**From:** [Sartori, Aline](#)  
**To:** [Ingrid Allen](#)  
**Subject:** RE: PB-1426 Proposed Minor Alterations - Request for NMR Letter  
**Date:** Tuesday, October 8, 2024 1:02:45 PM  
**Attachments:** [image004.png](#)  
[image008.png](#)  
[image009.png](#)

See attached newly proposed sheet IR-1 submitted to Town. As you can see, certain irrigation previously approved by FDEP that extends eastward of the dune area has now been removed. I just want to make sure that these modifications do not change the validity of FDEP's permit.

**Landscape Plan  
NEW RESIDENCE**  
3521 S Ocean Blvd., Highland Beach, FL 33487

IRRIGATION PLAN

Sheet  
L2  
Landscape Plan

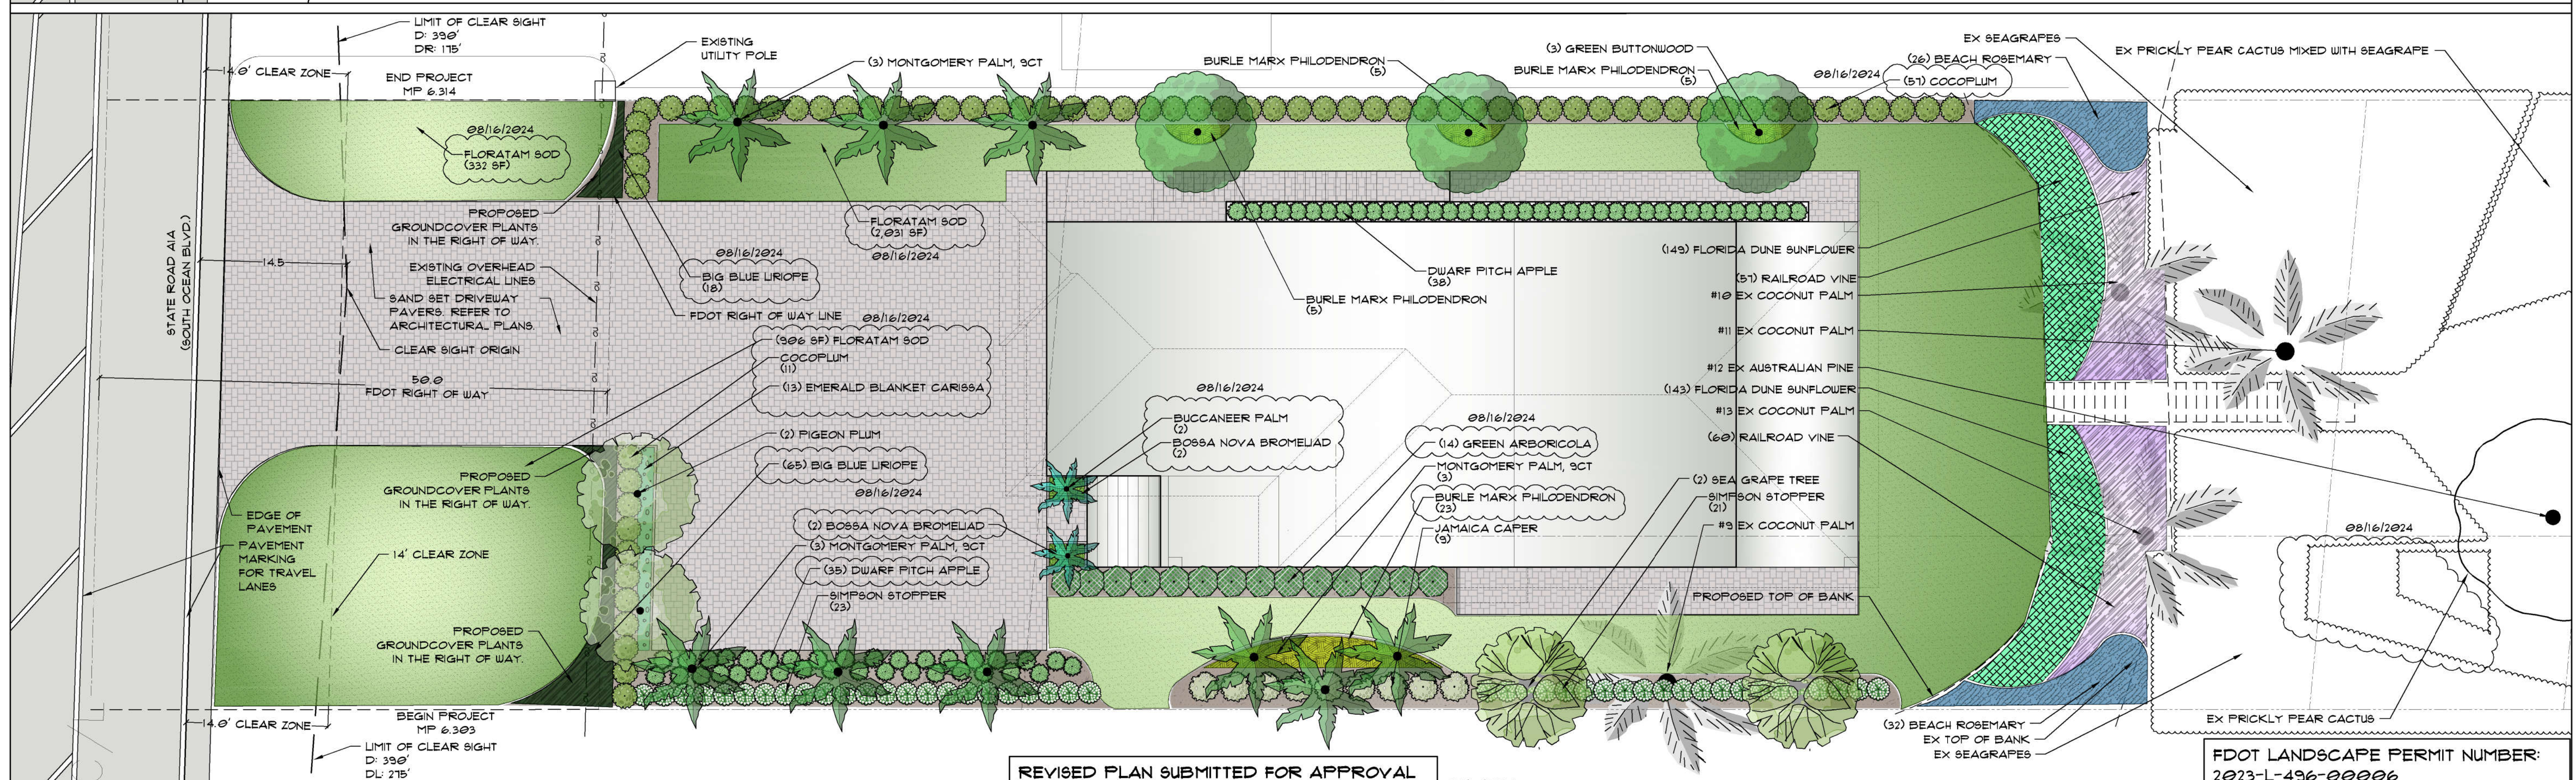
PLANT MATERIAL THAT WAS PREVIOUSLY APPROVED BUT IS NO LONGER INCORPORATED IN THE DESIGN  
 1 CAT PALM (CHAMAEDOREA CATARACTARUM) 1 GALLON  
 1 FIDDLEWOOD (CITHAREXYLUM FRUITICOSUM) 1 GALLON  
 6 PHILODENDRON "ROJO CONGO" (RED CONGO PHILODENDRON) 3 GALLON  
 11 PROPOSED SEAGRAPE SHRUBS HAVE BEEN REMOVED FROM THE EXISTING DUNE.  
 08/16/2024

IR-1  
 of 3

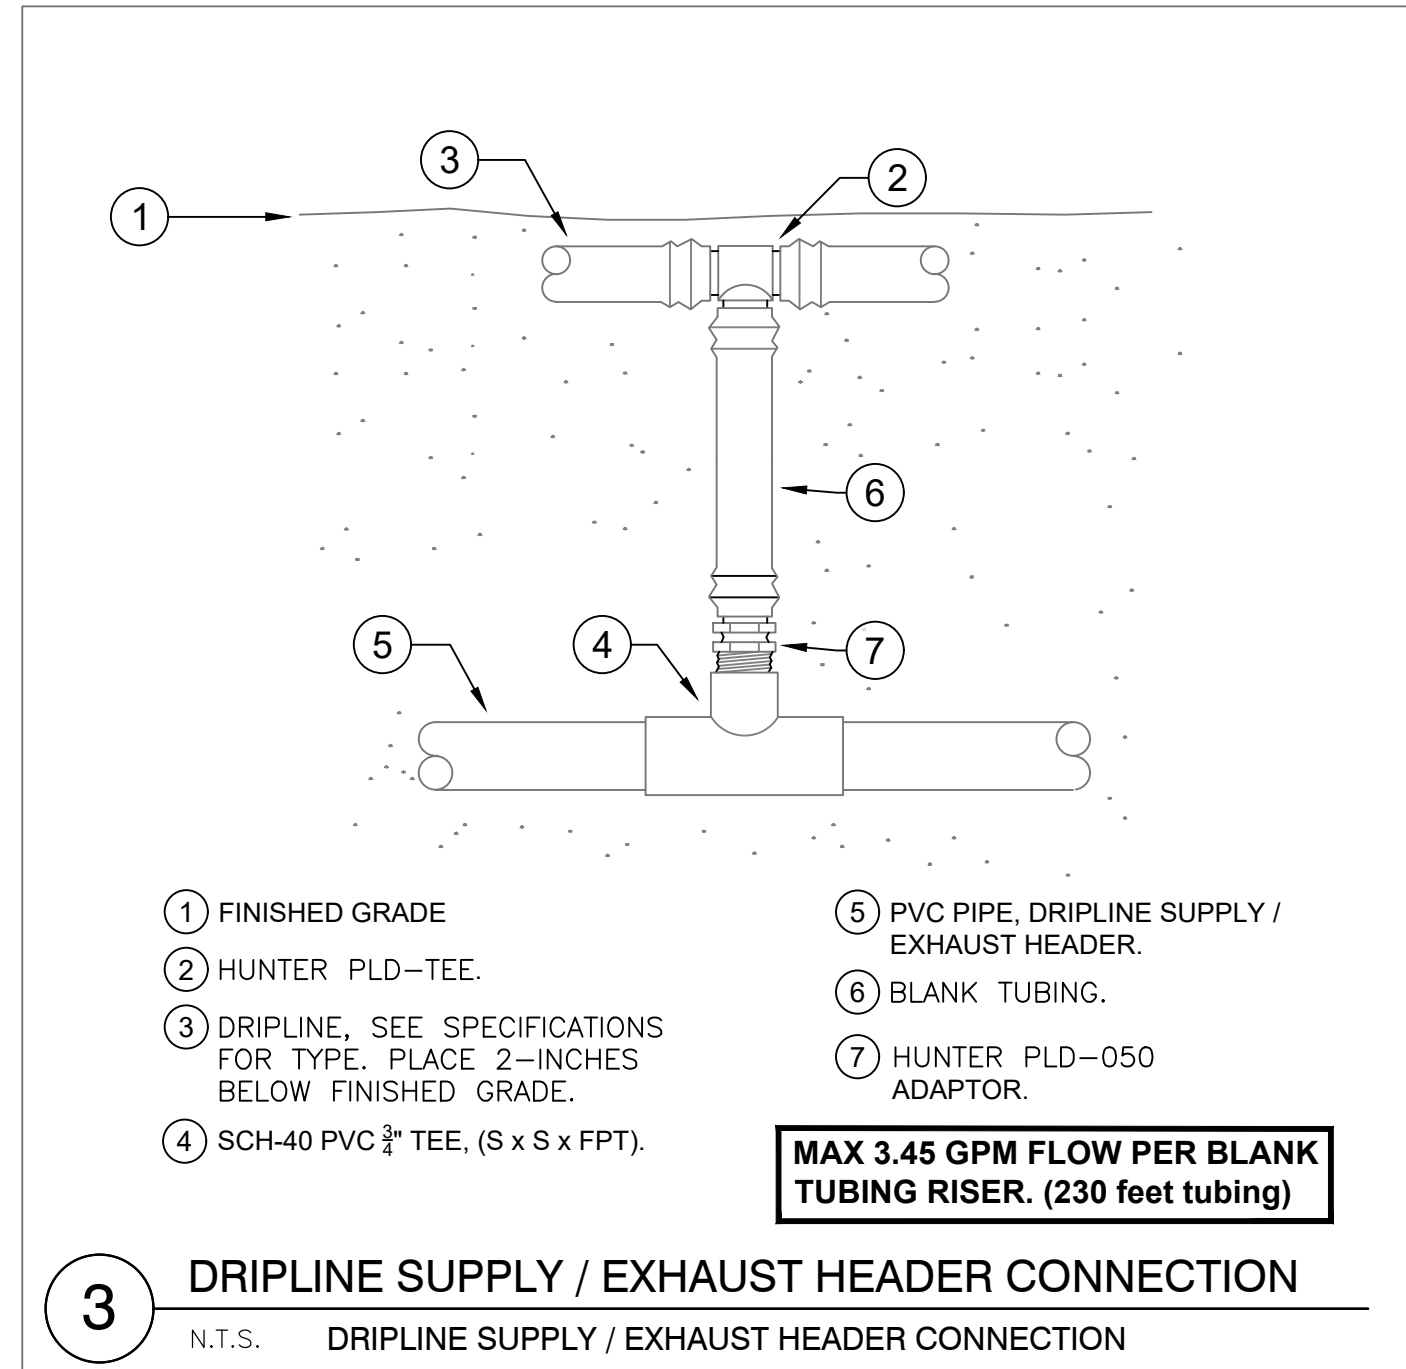
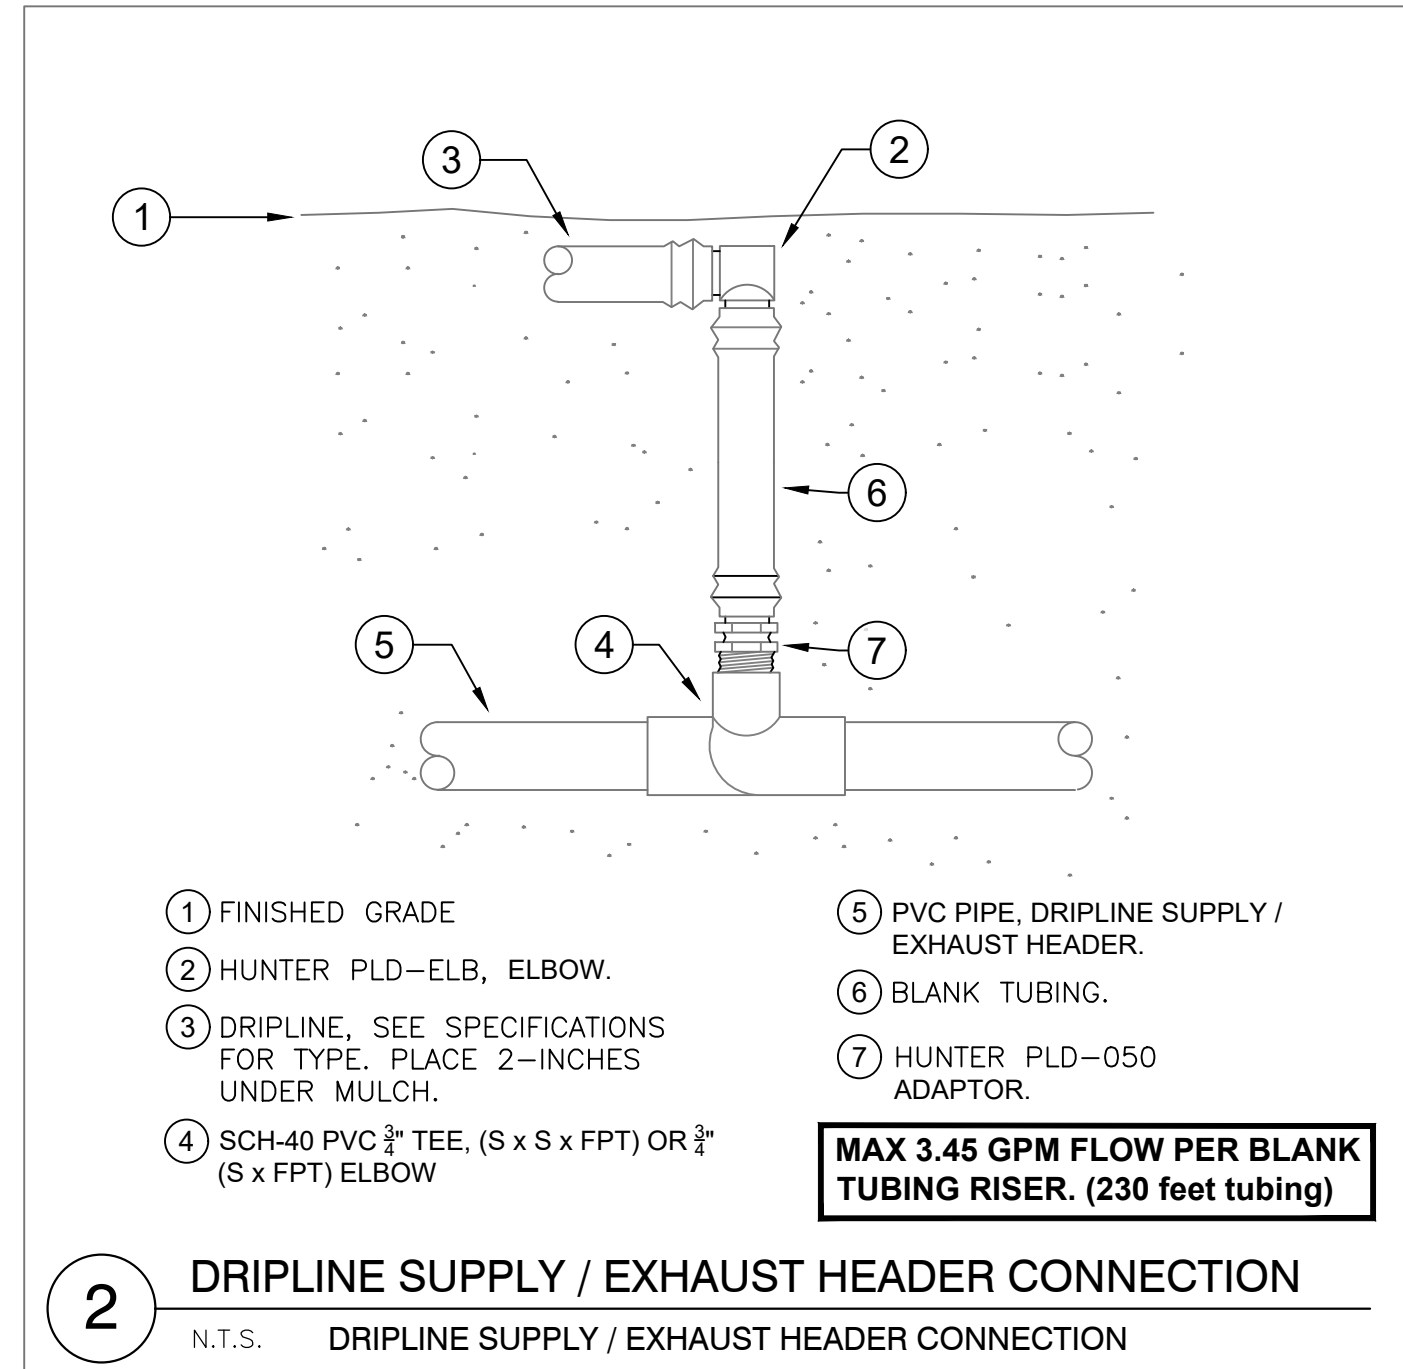
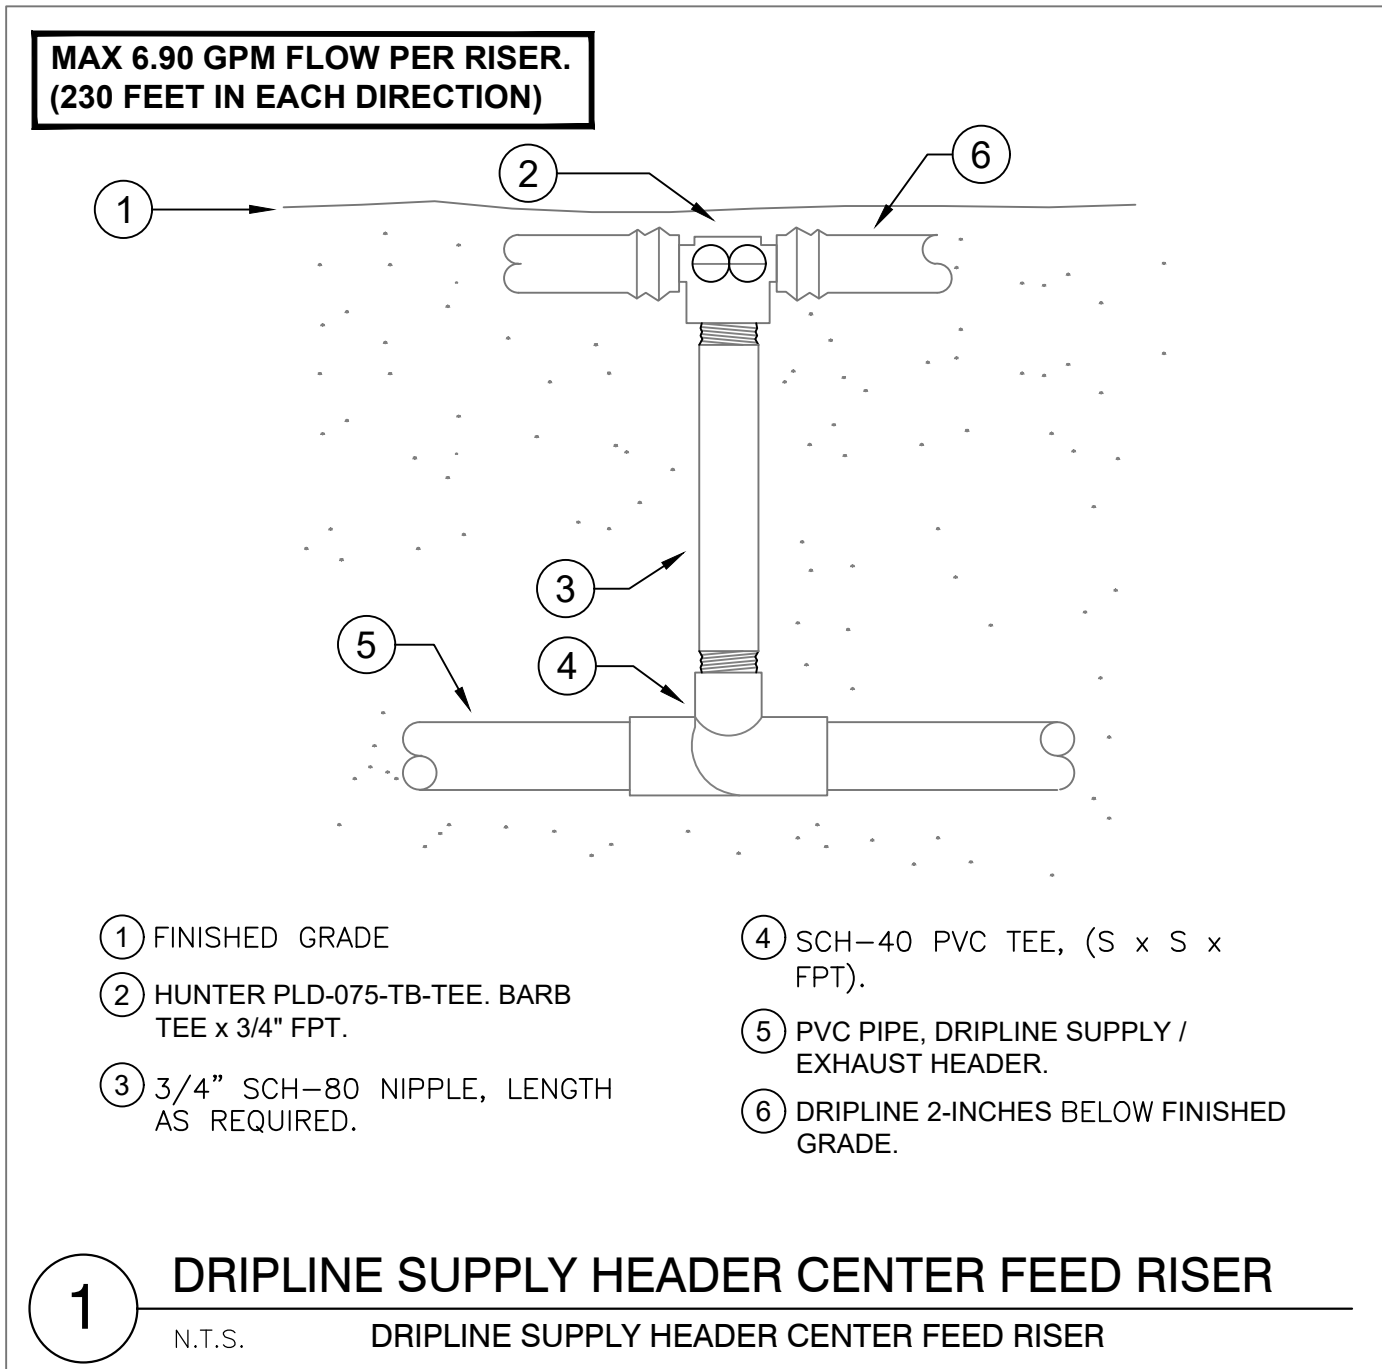
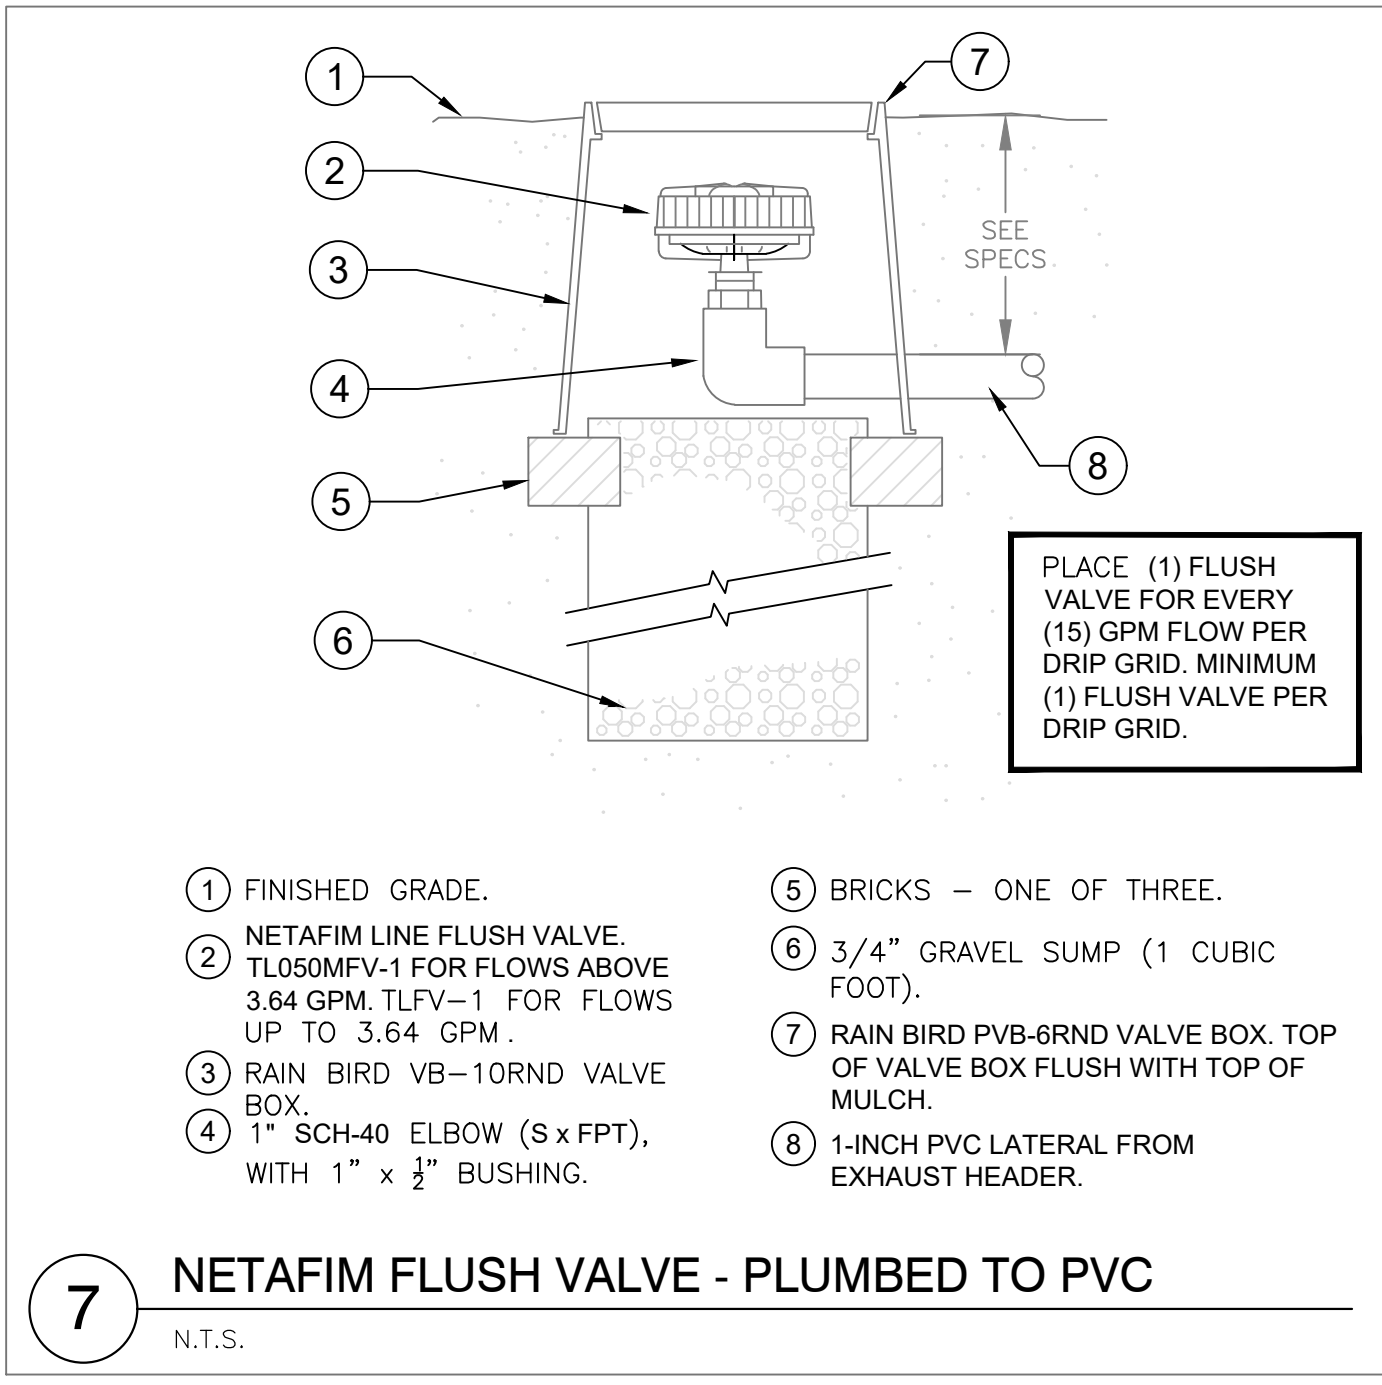
Hoping you can assist regarding above-referenced permit. The applicant's Irrigation plan sheet IR-1 (see attached "Landscape Plan") which FDEP previously approved is now being revised by the Applicant. The newly proposed sheet IR-1 submitted to the Town (see attached) has changed whereby certain irrigation in the dune vegetation has now been removed. Kindly advise if this removal affects the validity of the permit.

**DELTA 1 (IRRIGATION MODIFIED)**  
**SPRAY HEADS, DRIP LINE, and BUBBLERS**

TURF HEADS ON THE NORTH SIDE OF DRIVEWAY WERE MODIFIED TO ACCOMMODATE A LARGER TURF AREA.

TURF SPRAY HEADS ON EAST SIDE OF THE HOUSE WERE MODIFIED TO ACCOMMODATE A LARGER TURF AREA.

TURF SPRAYS HEADS WERE MODIFIED ON THE SOUTH SIDE OF MAIN ENTRANCE TO THE HOUSE TO ACCOMMODATE THE NEW LANDSCAPE LAYOUT.

TURF SPRAY HEADS WERE MODIFIED ON THE SOUTH SIDE OF DRIVEWAY TO THE HOUSE TO ACCOMMODATE A SMALLER TURF AREA.

DRIPLINE LAYOUT WAS MODIFIED ON THE WEST SIDE OF THE PARKING AREA OF ACCOMMODATE THE REDUCED PLANTING AREA.

DRIPLINE LAYOUT WAS MODIFIED ON THE SOUTH SIDE OF THE MAIN ENTRANCE OF THE HOUSE TO ACCOMMODATE THE NEW LANDSCAPE LAYOUT.

ONE BUBBLER WAS REMOVED FROM THE PLANTING AREA TO THE WEST OF THE PARKING.

THE VALVES ALONG THE NORTH PROPERTY LINE HAVE BEEN RECONFIGURED TO ACCOMMODATE THE REVISED LANDSCAPE DESIGN. THE ORIGINAL PALM AND NEW BOTH HAVE 6 VALVES ALONG THIS PROPERTY LINE BUT THE SPACING HAS BEEN MODIFIED.

THE ORIGINAL PLAN HAD ONE VALVE ON THE EAST SIDE OF THE HOUSE AND THE NEW PLAN HAS ONE ON THE EAST SIDE OF THE HOUSE.

THE ORIGINAL PLAN HAD 10 VALVES ALONG THE SOUTH PROPERTY LINE. THE NEW PLAN HAS 4 VALVES ALONG THE SOUTH PROPERTY LINE TO ACCOMMODATE THE MODIFIED LANDSCAPE LAYOUT.

THE ORIGINAL PLAN HAD 1 VALVE WEST OF THE PARKING AREA AND THE NEW PLAN HAS 2 VALVES TO ACCOMMODATE THE NEW LANDSCAPE LAYOUT.

**DELTA 2 (VALVE SCHEDULE MODIFICATIONS)**  
 THE ORIGINAL PLAN HAD A TOTAL OF 18 VALVES AND THE NEW PLAN HAS A TOTAL OF 14 VALVES.

**DELTA 3 (WATERING SCHEDULE MODIFICATIONS)**  
 THE ORIGINAL PLAN HAD A TOTAL OF 18 VALVES IN THE WATERING SCHEDULE WITH A TOTAL GALLON PER DAY OF 1,554. THE NEW PLAN HAS A TOTAL 14 VALVES WITH A TOTAL GALLON PER DAY OF 1,573.

These modifications will not affect the validity of the permit.
